XEROX EOD	Project DO	Maintenance Panel	File D0mp01.sil	Designer Rosen	Rev Gc	Date 6/11/79	Page 01
-----------	------------	-------------------	-----------------	----------------	--------	--------------	---------

XEROX EOD	Project DO	Maintainance Panel Changes	File DOMPchanges.sil	Designer Rosen	Rev Gc	Date 6/11/79	Page 01
--------------	---------------	----------------------------	-------------------------	-------------------	-----------	-----------------	------------

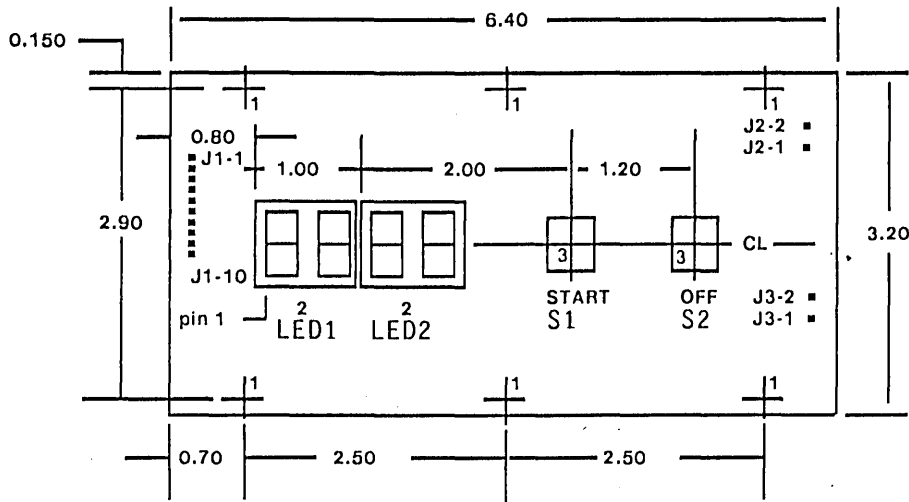
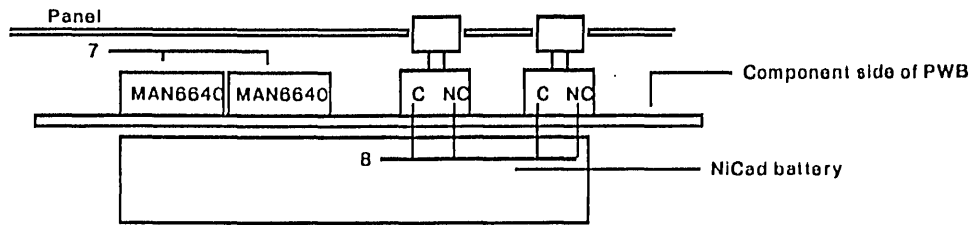
Changes for revision Ga to Gb (4-27-79 CT)

- 1) Changed IC2 from S38 to N38
- 2) Changed C8 from 100 pf to 200pf
- 3) Changed R2 from 470 ohms to 47 ohms (Initial loading chart was incorrect).
- 4) Removed components C13, C14, and R39

Changes for revision Gb to Gc (6-11-79 CT)

- 1) Added .01uf cap and 1k resistor in series with PnlBoot. This is the line that boots the machine; this change causes the boot signal to be a negative-going pulse at the end of the ~700ms time delay that starts when the boot button is released.
- 2) Added NPN emitter follower to signal TimeOut to assist the feeble CMOS output of the TMS1000C.
